UNITED STATES  
DEPARTMENT OF THE INTERIOR  
BUREAU OF LAND MANAGEMENT

FORM APPROVED  
OMB NO. 1004-0137  
Expires: January 31, 2018**SUNDRY NOTICES AND REPORTS ON WELLS**  
**Do not use this form for proposals to drill or to re-enter an abandoned well. Use form 3160-3 (APD) for such proposals.****SUBMIT IN TRIPLICATE - Other instructions on page 2**

Author:	MRM (7/2017)	Well No.	#1
Well Name	Piper Federal	API #:	30-015-35788
Field	Lusk	Prop #:	
County	Eddy	Zone:	Delaware / Bone Spring
State	New Mexico		2310 FNL & 330 FEL
Spud Date	10/10/2007		Sec 12 T19S R31E
GL	3,618'		
KB

Author:	MRM (7/2017)	
Well Name	Piper Federal	Well No. #1
Field	Lusk	API #: 30-015-35788
County	Eddy	Prop #:
State	New Mexico	Zone: Delaware / Bone Spring
Spud Date	10/10/2007	2310 FNL & 330 FEL
GL	3,618'	Sec 12 T19S R31E
KB

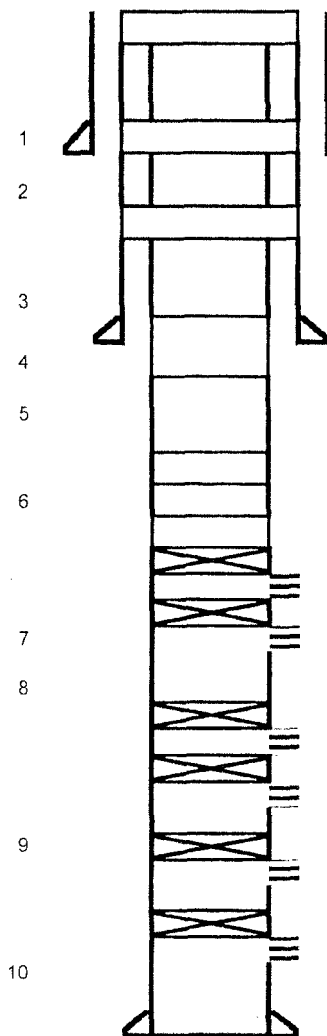
### 5. Perf & Sqz 45 sx @ 2750-2650'. (Yates)

### 3. Spot 25 sx @ 5000-4900. (Delaware)

1. Tag CIBP @ 6900'. Circulate hole w/MLF. Spot 25 sx cement @ 6900-6647. WOC & Tag.
2. Circulate hole w/ MLF. Pressure test csg.
3. Spot 25 sx @ ~~5000-4900~~. (Delaware) 5058-4908
4. Spot 35 sx @ 3583-3315. WOC & Tag. (Shoe & Queen)
5. Perf & Sqz 45 sx @ 2750-2650'. (Yates) 2603
6. Perf & Sqz 45 sx @ 810-710. WOC & Tag. (Shoe & Rustler)
7. Perf & Sqz 45 sx @ 100-surface.
8. Cut off wellhead, verify cmt to surface, weld on Dry Hole Marker.

Below ground level dry hole marker required. LAC Timing
